COMMITTEE OF THE WHOLE JUNE 14, 2011

**SITE DEVELOPMENT FILE DA.10.101
DUFFERIN CONTWO INVESTMENTS LTD.
WARD 4**

Site Plan

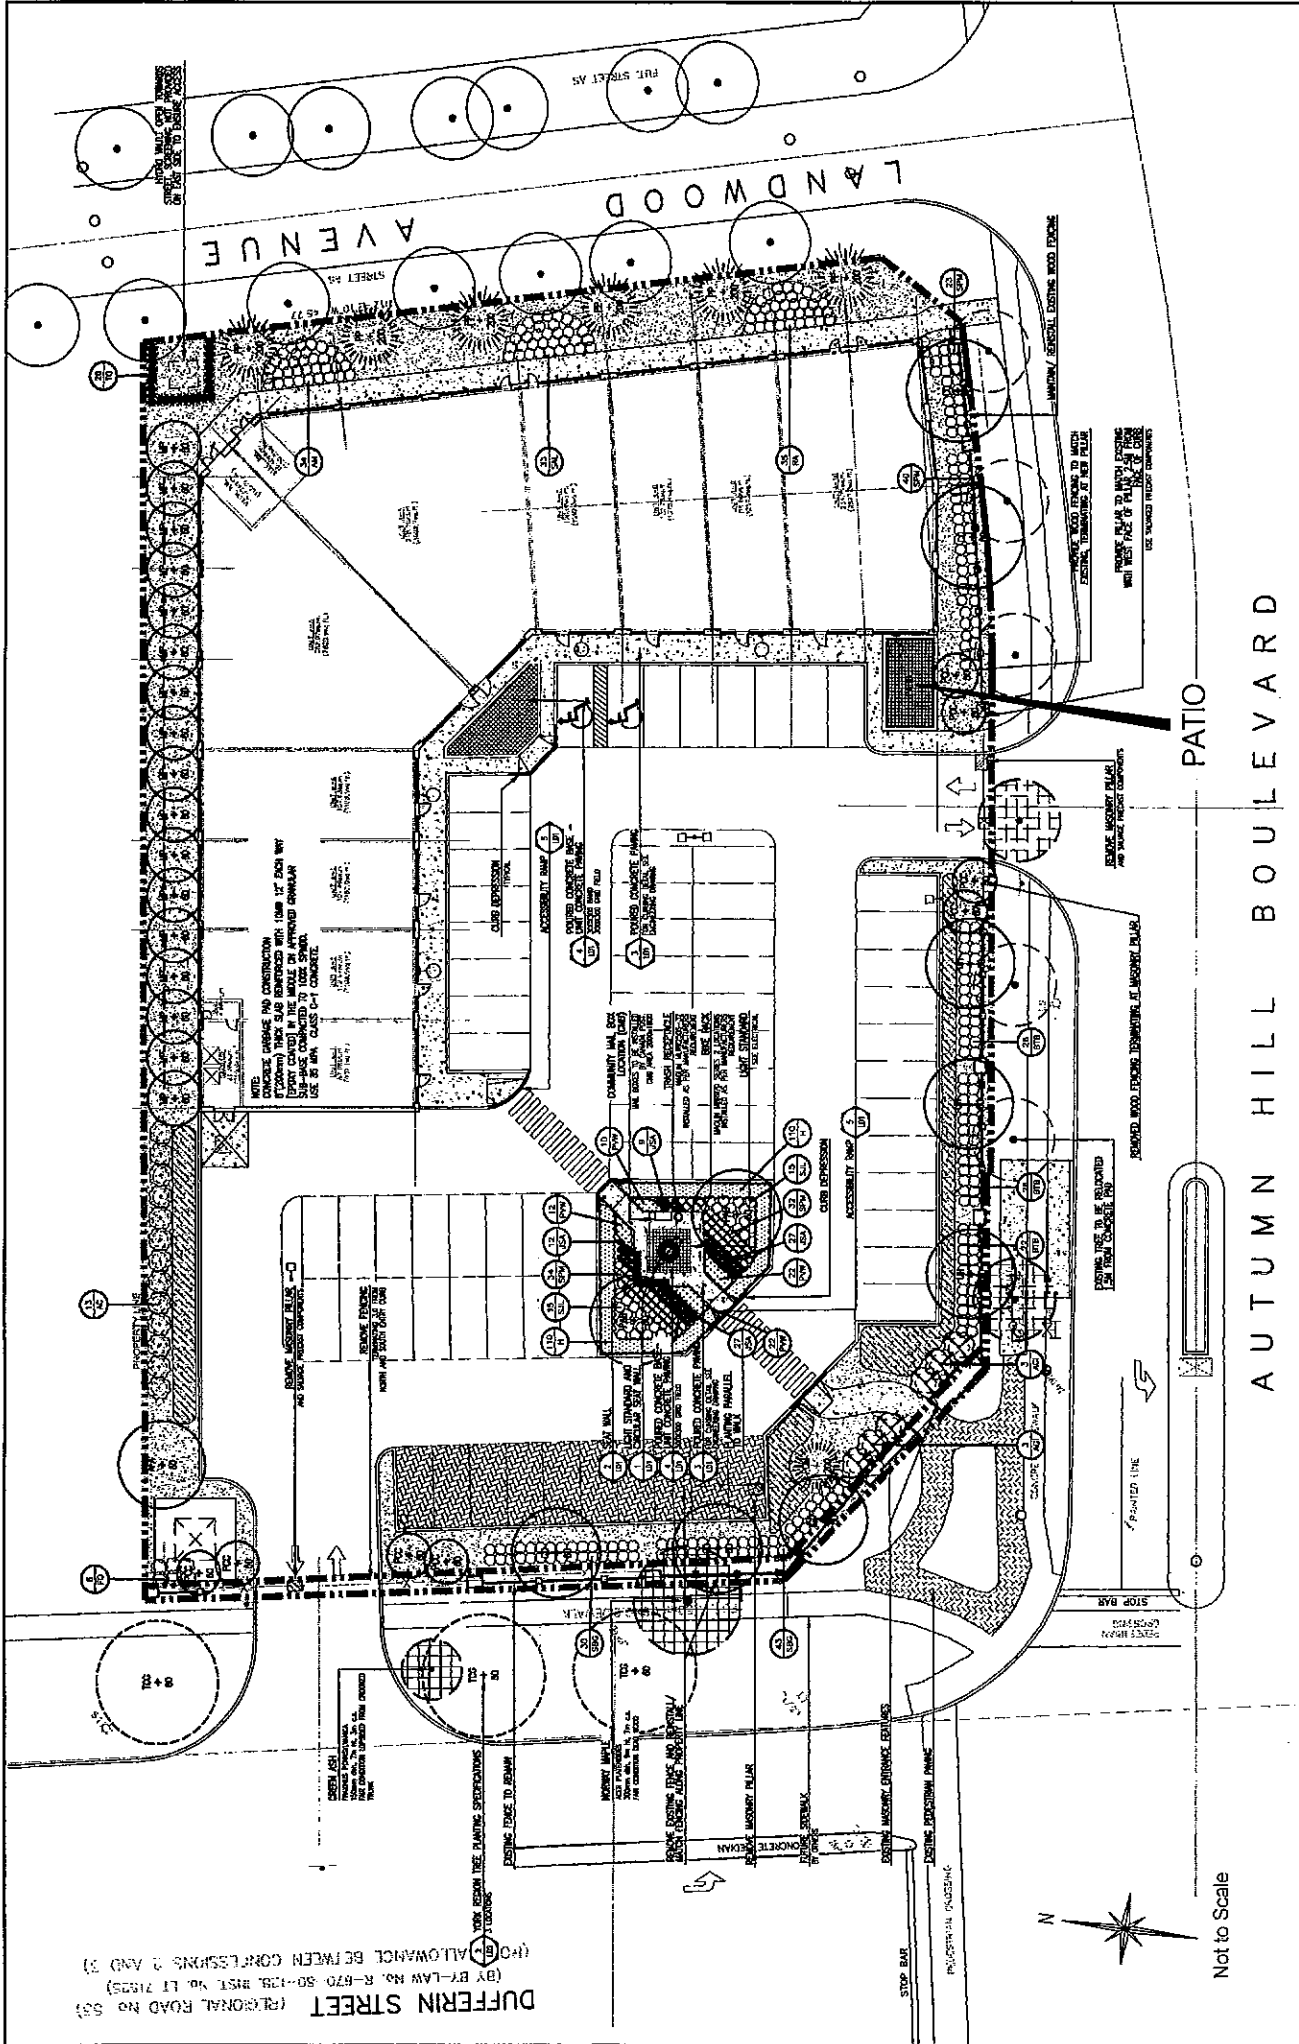
The proposed site plan includes a single storey, L-shaped, multi-unit, commercial building, with access from Dufferin Street and Autumn Hill Boulevard, with associated parking and landscaped areas, as shown on Attachments #3 and #4. The Development Planning Department is satisfied with the site plan and landscape plan, which includes perimeter landscaping around the site and a landscaped pedestrian walkway connection extending from the arterial intersection through the site to the building. In addition, the site plan facilitates a planned outdoor patio for an eating establishment. Prior to final approval of the application, the site plan and landscape plan must be approved to the satisfaction of the Vaughan Development Planning Department.

- i) a 1.5m wide sidewalk along Dufferin Street and the related cost estimate;
- ii) pedestrian walkways connecting the site to the existing and proposed municipal sidewalks;

- vii) the site servicing and grading plan does not reflect the site plan. The Owner must confirm which drawing is correct and shall revise the other plans and stormwater management plan/report, accordingly;

The applicant has not provided the City with a revised submission. Prior to the execution of the Site Plan Letter of Undertaking, the final engineering plans and requirements as outlined must be approved to the satisfaction of the Vaughan Development/Transportation Engineering Department.

North, South, & East Elevation

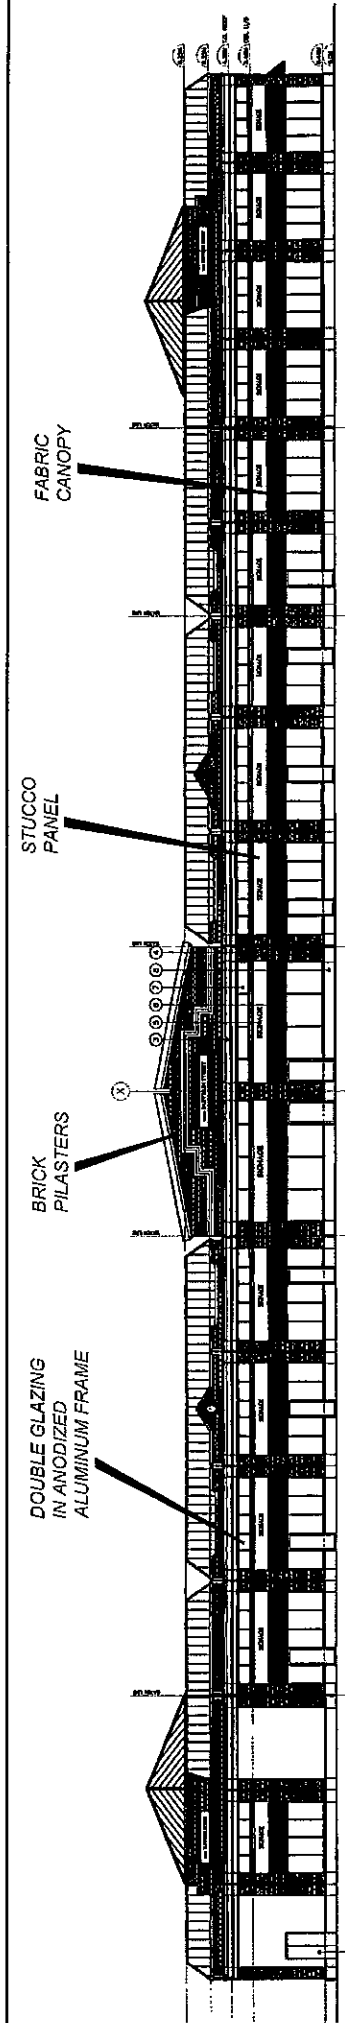
The proposed building elevations are shown on Attachments #5 and #6. The proposed L-shaped building is single storey, and finished in brick masonry and stucco and with clear glazed windows. The rear of the retail units will face Landwood Avenue (a residential street) and the rear yards of the existing residential properties to the north. The east elevation will be consistent in appearance with the west and south elevations. The City requires high quality elevations for these building facades to mitigate the impact of the residential/commercial interface and to provide a more appealing streetscape along Landwood Avenue, which the applicant has achieved below the roofline.

The Development Planning Department has reviewed the building elevations shown on Attachments #5 and #6 and are not satisfied with the proposed roof design and parapet which consists of a low-pitched, blue metal roof with a parapet utilizing triangular and semi-circle parapet elements. The Development Planning Department requires that the building elevations be revised to include further parapet wall/roof articulation to provide for attractive and visually appealing roof lines and to utilize a roofing material and design that is complementary with those used throughout the Thornhill Woods community (ie. higher brick, precast or stone parapet with more articulation of the roofline; not a low flat metal roof).

- a) that the Vaughan Development Planning Department continue to work with the Applicant and their consultants to address the outstanding issues respecting the building elevation drawings, which must be substantially upgraded to improve the roof articulation and parapet design; and,

The applicant contends that the City's request for landscape screening along the north and east building facades will partially screen the visibility of the roof, particularly above the fence from the rear yards of the adjacent residential lots to the north. The applicant further contends that the south and west building elevations replicate a pattern intended to give the impression of "individual houses around a piazza, rather than a commercial façade". The Development Planning Department is currently working with the applicant and their architect to achieve the recommended changes being sought by Staff, to the roof design and parapet, as discussed in this report, in order to eliminate the necessity for an OMB Hearing.
